## P.282.—B.R. 642 (J)—Summary of Japanese Warships—Amendment No. 1

(N.I.D. 1973/45.—12 Apr. 1945.)

Page 1. "YAMATO" class. Delete all references under heading and insert the following:—

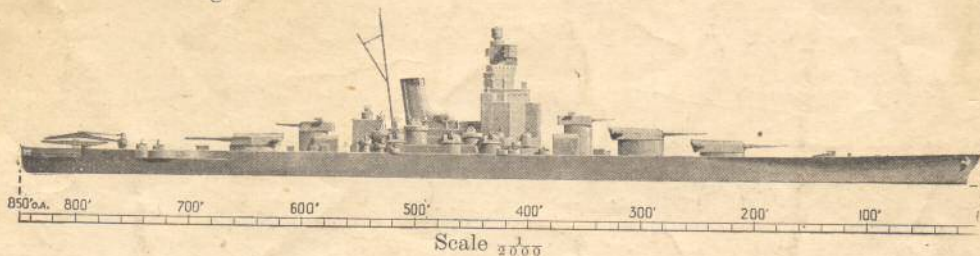
ARMOUR : ? BELT ? DECK  
 Length : 850 ft. (o.a.)  
 Breadth : 120 ft. (extreme)  
 Draught : 30 ft. 2 in. (mean at standard)  
 Displacement : 42,000 tons (standard)  
 Speed : 25 knots

9—16-in. (triple turrets)  
 6—6-in. (triple turrets)  
 12—5.1-in. (twin turrets)  
 12 to 16—4-in. H.A. (Singles)  
 12 to 15—2.24-in. or 1.57-in. A.A. (triple or twins)  
 2—catapults

May carry two midget submarines.

Page 3. "ISE" class. Delete all references under heading and insert the following:—

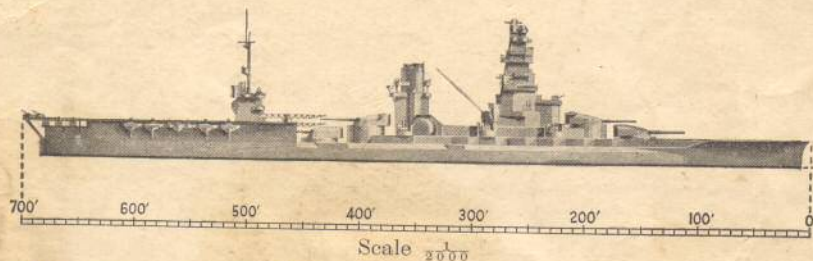
ARMOUR : 12-in. BELT ?-in. DECK  
 Length : 640-ft. 0-in. (p.p.) 683-ft. 0-in. (o.a.)  
 Breadth : 94-ft. 0-in. + bulges  
 Draught : 28-ft. 8-in. (mean at standard)  
 Displacement : 29,990-tons (standard)  
 Speed : 22.5 to 23 knots (designed)

8—14-in. (twin turrets)  
 16—5.1-in. A.A. (twin mtgs.) Max. elevation : 85°  
 34—0.98-in. m. A.A. (twins) Max. range : 21,030-yards  
 11—0.51-in. m. A.A.  
 2 catapults 24 aircraft  
 Converted to CV-BBs.

Page 7. "SHOKAKU." *After* "ZUIKAKU" *add* "'UNRYO' and 'AMAGI'".

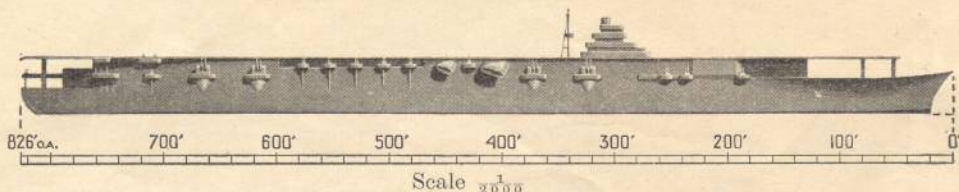
*Delete* existing profile and *insert* :—

Page 7. "TAIHO." *Delete* "No details available" and *insert* :—

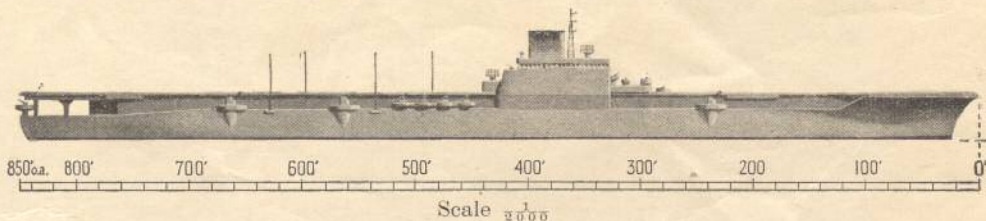
*Add* Length : 850-ft. (o.a.)  
 Displacement : ? 30,000-tons (standard)  
 Aircraft : 90

Page 8. "HITAKA", "HAYATAKA". *Delete* recognition notes "Has vertical funnel . . .", etc., and *insert* :—

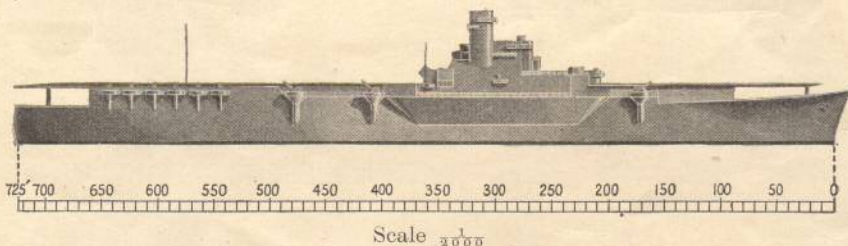
Length : *Amend to read* 745-ft. 0-in. (extreme)  
 Breadth : 90-ft. 0-in. (extreme)  
 Draught : 26-ft. 6-in. (aft full load)

Page 36. "MINEKAZE" class. *Delete* names "NADAKAZE", "NUMAKAZE", "MINEKAZE" and "YAKAZE".

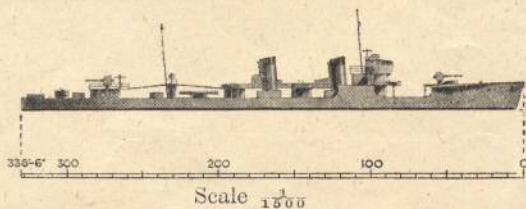
*Cancel* existing profile and *insert* :-

*Amend* armament to read "2—4·7-in., 11—0·98-in. m. A.A. (4 twins, singles), 1—21-in. D.R.T.T.".

“ DESTROYER (DD) CLASS — ‘ MATSU ’ ( )  
‘ TAKE ’ ‘ MOMO ’ ‘ UME ’ ‘ KUWA ’

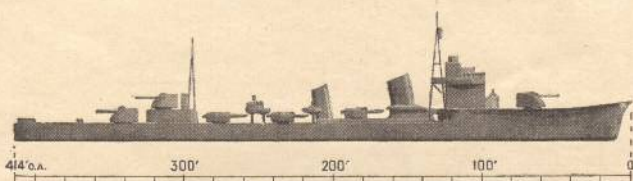
New page to be inserted between pages 36 and 37. To read as follows :—  
Page 36A.

Length : 320-ft. 0-in.  
Breadth : 33-ft. 0-in.  
Draught :  
Displacement : 1,500-tons  
Speed : 30 knots (designed)

3—5·0-in. H.A./L.A.  
24—0·98-in. m. A.A.  
5—0·51-in. m. A.A.  
1—24-in. Q.R.T.T.

Page 37. "AKITSUKI" class. *Delete* names "WAKATSUKI", "NIIZUKI" and "NUMATSUKI".

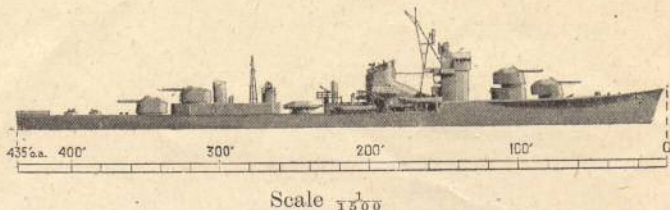
*Cancel* existing profile and *insert* :—

*Amend* data to read :—

Length : 435-ft. 0-in.  
 Breadth : 38-ft. 0-in.  
 Displacement : 2,300-tons  
 Speed : 34 knots (designed)

8—4-in. H.A./L.A.  
 8—0.98-in. m. A.A.  
 1—24-in. Q.R.T.T."
